TOWN OF BASSENDEAN

NOTICE OF A SPECIAL COUNCIL MEETING

4.1 Addendum Report for Joint Metro Central Development Assessment Panel Application – Form 1 – Development Assessment Panel Application for Convenience Store Providing for the Sale of Fuel and Convenience Goods (Vibe) – Lot 75 (No. 72) Walter Road East (cnr Marion Street), Eden Hill. Owner: K. & W. Sales & Distribution Pty Ltd. Applicant: Planning Solutions (Ref: DABC/BDVAPPS/2018 – 093 – Christian Buttle, Senior Planning Officer)

Form 1 – Responsible Authority Addendum Report
(Regulation 12)

TABLE 2.1
DESIGN VEHICLE DIMENSIONS

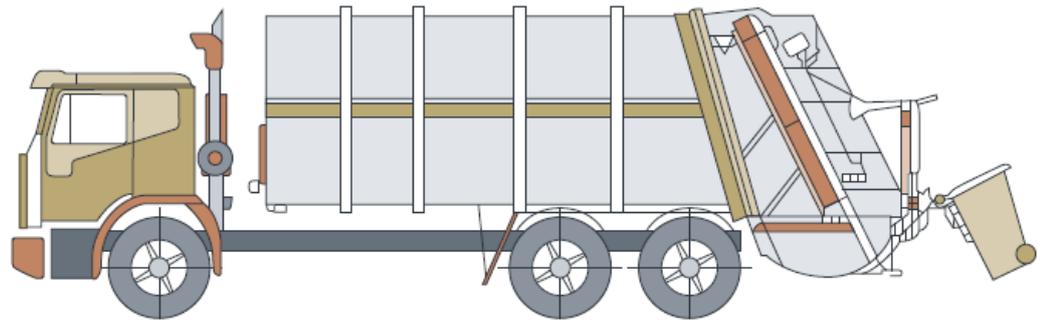
Town of Bassendean Response to Transcore Comments

Clause 3.2 of AS 2890.1 states that:

“Facilities shall be designed using one or more of the design vehicles specified in Section 2 which most nearly conform to the vehicles actually using the site and shall include provision for specialist vehicles where required.”

The design vehicles which most nearly conform to the vehicles actually using the site are Heavy Rigid Vehicle (HRV) for waste management and Articulated Vehicle (AV) for fuel tanker deliveries.
